To: Santa Clara Valley Water District Board Members
5750 Almaden Expressway
San Jose, CA 95118

As a Santa Clara valley resident and native Californian I understand the economic value of new water capture systems and our long-term water supply challenges, but the proposed Pacheco Reservoir Expansion Project (Pacheco Dam project) will likely have many profound and significant negative environmental impacts, cause unconscionable damage to a region rich in Native American artifacts and human remains, and is simply unjustifiably expensive for the amount of water it could provide. In this letter I will submit the evidence to support those concerns.

One major, multi-faceted problem with the Draft Environmental Impact Report (DEIR) for this project is that it either minimizes or outright fails to disclose all the environmental impacts of the project. It acknowledges, for example, that some plant and animal species within the project area are “sensitive”, but fails to point out that the State of California recognizes a *rank* of sensitivity levels. [Table 3.5-1 from the 2021 DEIR is shown below.]

Figure ES-5. Comparison of Steelhead Cohort Scores for Pacheco Creek for the Proposed Project and Existing and Future Baseline Conditions

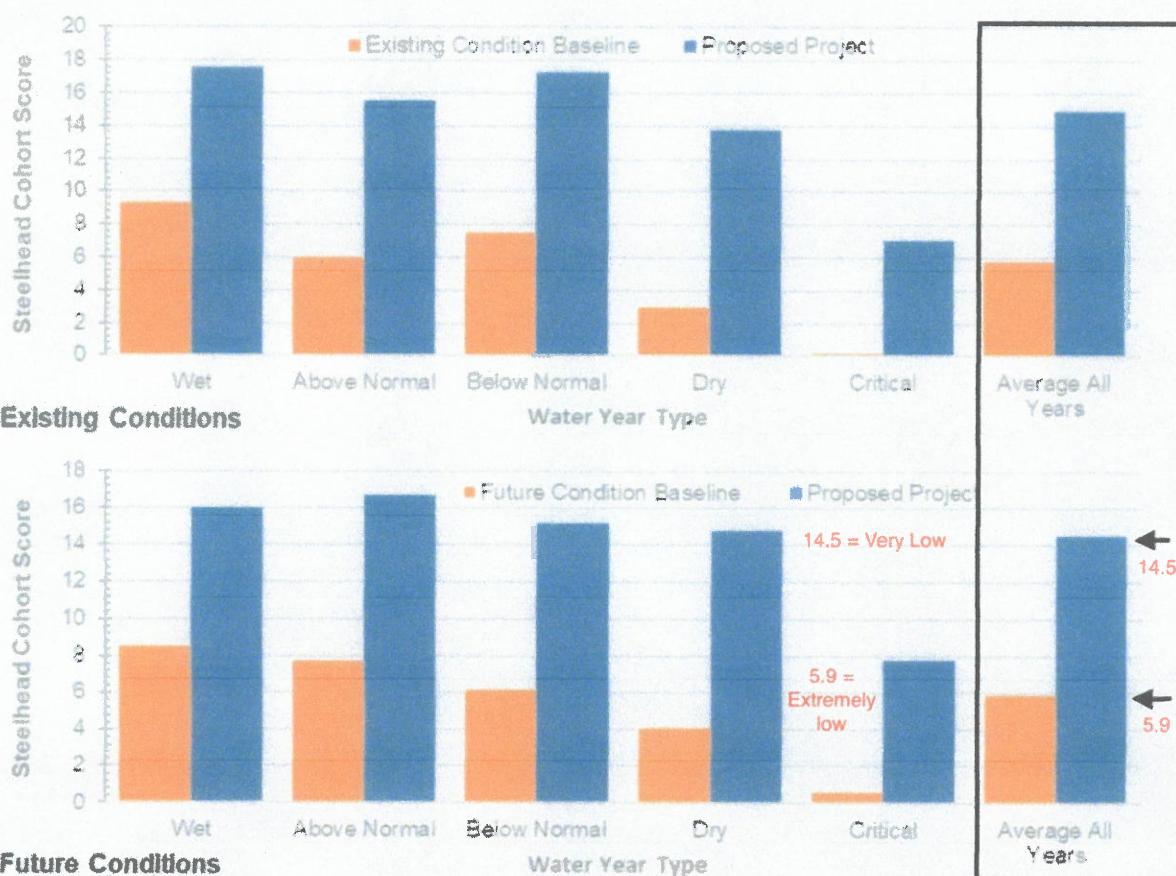
As pointed out by Dr. Jeffrey Michaels in his Nov. 29, 2021 analysis of the Pacheco Dam project (13), the Feasibility Documentation provides no evidence that habitat improvements, *per se*, will create a steelhead population in Pacheco Creek, especially considering the rather **meager increase in habitat suitability** the project proposes to provide. Consider the Figure ES-5 (below) from the DEIR.

Note that for all the many millions of dollars the project proposes to spend on SCCC steelhead stream flow and habitat improvement, by their own DEIR data the **“Steelhead Cohort Score”** (which they propose is a measure of habitat suitability) is increased only from 5.9 out of 100 (*extremely low* habitat suitability) to 14.5 out of 100 (*a very low* habitat suitability). As an engineer colleague commented, “This looks like an increase from *terrible* to *merely*

pathetic". Finally, even if the project does provide *marginally* "improved steam flow conditions", it is **irrelevant unless** the SCCC steelhead re-inhabits the stream **and shows increased occupancy, and increased survival and reproduction of** the steelhead population in that stream.

Figure 1. Net Present Value of Claimed Public Benefits from Pacheco Dam as Compared to Estimated Values Following WSIP Guidance

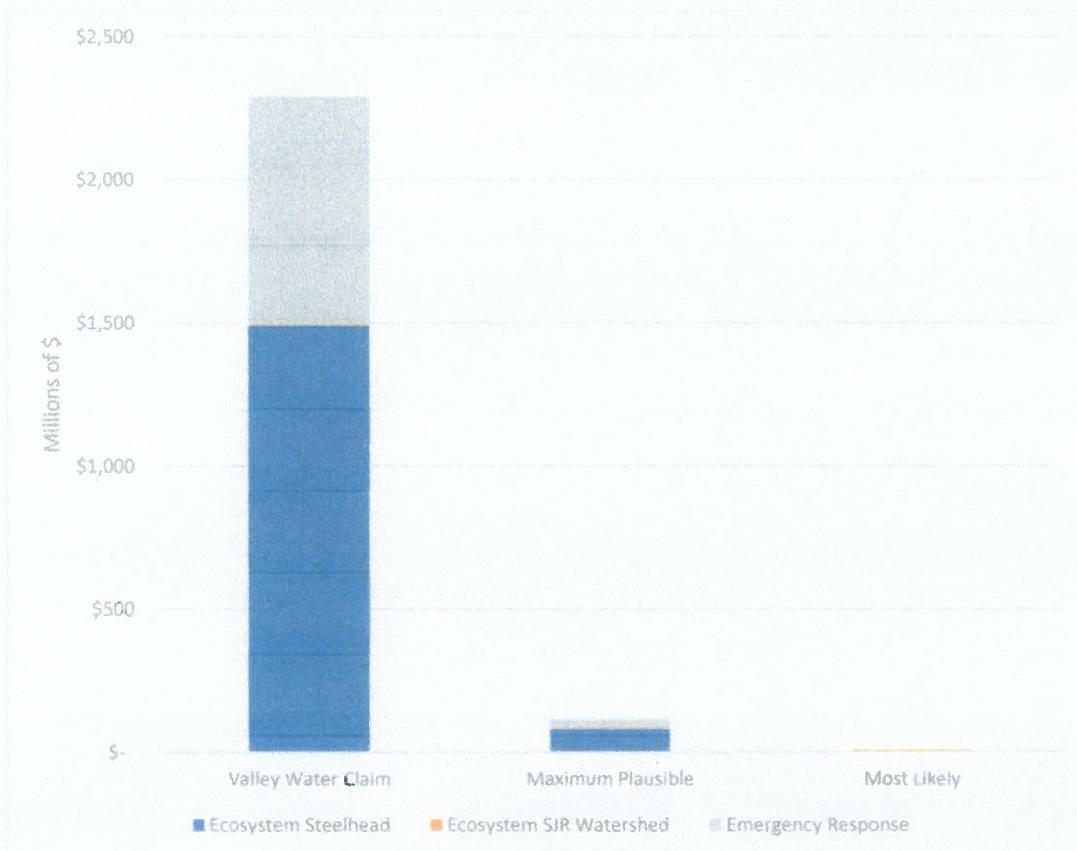
"It is apparent that an accurate benefit-cost analysis is not even close to supporting the \$2.12 billion cost to Valley Water ratepayers and the State of California, and the public benefits are far too low to justify the nearly \$500 million award Valley Water seeks from the WSIP. As shown in Figure 1 (below), Valley Water's claimed public benefits are more than twenty times the maximum plausible value of public benefits."

Dr. Michael presents a very clear cost-accounting to support the graphs in Figure 1 above, very logically debunking the hyperinflated monetary “public benefits” claimed by Valley Water. His analysis of the claimed “public benefits” resulting from changes to SCCS steelhead habitat in the project are, for example, compared to other steelhead projects in California and among a group of Western states in the USA. The West Coast Region of the National Marine Fisheries Service (NMFS), for example, also has a recovery plan for SCCS steelhead population located in the watersheds from the Pajaro River south to Arroyo Grande Creek. NMFS estimates the recovery cost for the SCCS steelhead population will be \$560 million borne over the next 80 to 100 years, with the benefits of the myriad projects proposed far outweighing the benefits of the improvement in habitat on Pacheco Creek. Most tellingly, the benefit estimate Valley Water has placed on the habitat improvement from the Pacheco Dam project is nearly *three times* the estimated cost for the NMSF project that will substantially improve steelhead habitat throughout the *entire range of the species!*
